ITEM NUMBER	9.2
SUBJECT	Planning proposal for land at 55 Aird Street, Parramatta
REFERENCE	RZ/18/2015 - D04177817
REPORT OF	Project Officer Land Use
LANDOWNER	Charles Apartments Pty Ltd
APPLICANT	Statewide Planning Pty Ltd

To allow Council to consider a planning proposal seeking to remove the maximum height limit (currently 36 metres/11 storeys) and increase the floor space ratio for land at 55 Aird Street, Parramatta for the purposes of requesting a Gateway determination from the Department of Planning and Environment.

Figure 5 Typical floor plan (Source: Applicant's Urban Design Report)

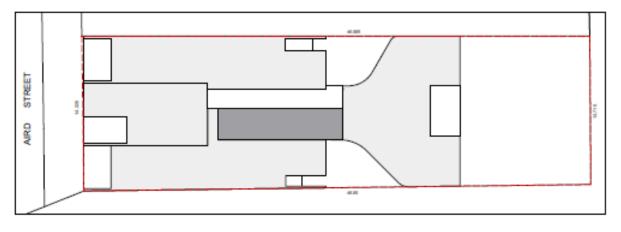
- 20. The Applicant's Urban Design Report does not provide clear floor plans, however the built form indicated demonstrates that compliance with the SEPP 65 Apartment Design Guidelines for building separation cannot be achieved. Light wells are relied upon (see Figure 5) as a means of achieving natural light and ventilation which is inconsistent with the objectives of the ADG. To achieve a tower form zero lot side setbacks are required and 120m high blank walls are utilised in order to respond to building separation and privacy requirements. As a result, the onus is placed on neighbouring landowners to provide the required setbacks.

- 38. Even with an FSR of 6:1 the floor plan presented in the Urban Design Report, see Figure 5, if retained will result in compromised apartments that fail to comply with the objectives of the ADG. If the floor plate presented in the Urban Design Report was to be reduced as there would be more opportunity to comply with the ADG and it would provide for better built form outcomes.
- 39. **Option B:** Apply an FSR of 10:1.

Figure 6 Amalgamation opportunities (Source: Council's GIS)

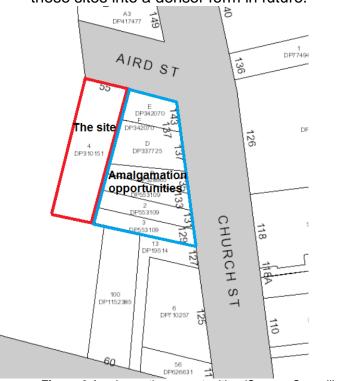
- 23. The CBD Planning Proposal envisages smaller sites such as 55 Aird Street and the developments fronting Church Street to amalgamate to improve development outcomes. If the sites are to progress separately seeking tower forms access to the sites will be compromised and blank walls will be utilised extensively. The applicant's Urban Design Report details a 38 storey building fronting Aird Street with a 120 metre blank wall facing Church Street. It will not be possible for all sites to achieve inter tower separation and setbacks in accordance with ADG requirements. There is opportunity to amalgamate the sites (outlined in red and blue in Figure 6).

Figure 7 Development options for neighbouring sites (Source: Urban Design Report)

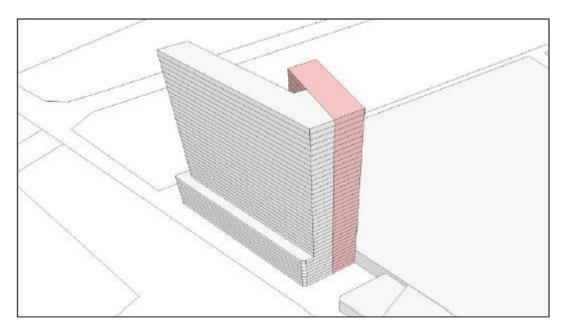
- 25. The Urban Design Report submitted by the applicant includes indicative building envelopes on the adjacent sites to the east along Church Street, see

Figure 7. The design has been prepared with the assumption that the other landowners along Church Street are able to amalgamate. Due to the zero lot setback of 55 Aird Street the Church Street building envelope is unable to develop a similar form. A minimal inter tower setback is provided requiring blank walls for both towers. The Church Street envelope is also required to provide a 6m setback to Church Street. Tower setbacks are essential to reduce wind tunnels and provide a comfortable human scale for pedestrians at street level. The indicative building envelopes presented at Figure 7 demonstrate the onus placed on the neighbouring sites to provide a setback between the two tower forms.

Figure 8 Development options (Source: Council modeling)

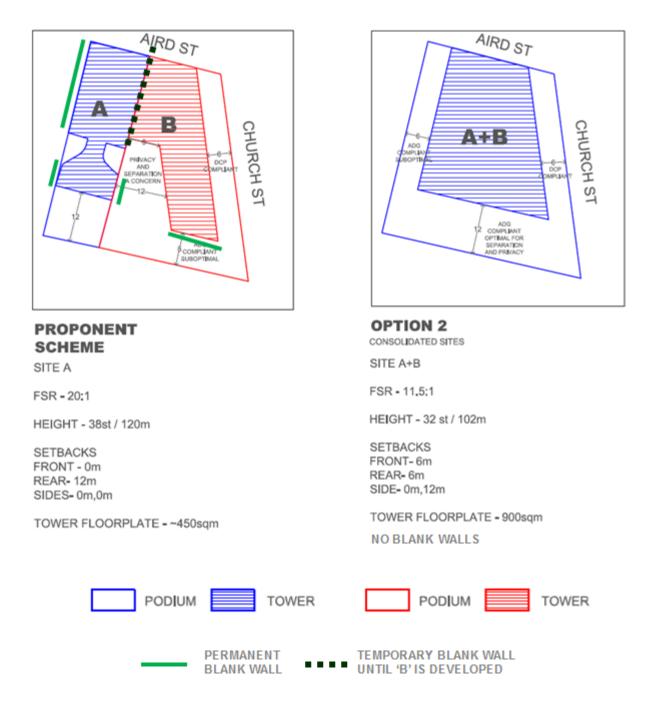
- 26. Figure 8 demonstrates how the sites along Church Street could be developed if Council adopts FSRs of 20:1 or 11.5:1. The Proponent's Scheme is informed by the Urban Design Report submitted with the original planning proposal. There is 12 metres provided between apartments in towers A and B creating privacy concerns, the units at the rear would receive limited sun access and ventilation. This scheme is non-compliant with the ADG, features 38 storey blank walls and provides minimal front, side and rear setbacks.
- 27. Option 1 demonstrates a built form that could be accomplished should the subject site amalgamate with the sites along Church Street, reaching an FSR of 11.5:1 including design excellence (in keeping with CBD PP). Site amalgamation could result in a development that includes no blank walls, appropriate setbacks in keeping with the DCP, a defined podium with tower

setback and improved development potential for all sites. The design at Figure 8 complies with the ADG providing ventilation, solar access and privacy.
